## DRAWING AMENDMENTS

REMARKS

Fig.1

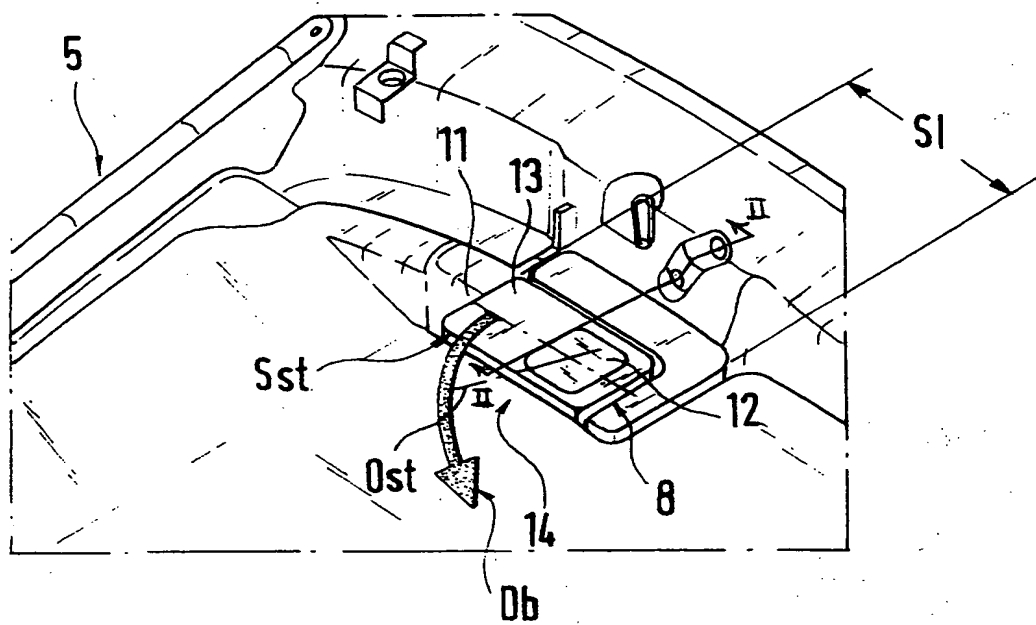
Please amend Figures 1, 2, 6, and 8 by replacing the drawing sheets including those figures with the replacement drawing sheets appended to this Reply. Also appended to this Reply are copies of the original drawing sheets showing, in red, the changes made to Figures 1, 2, 6, and 8.
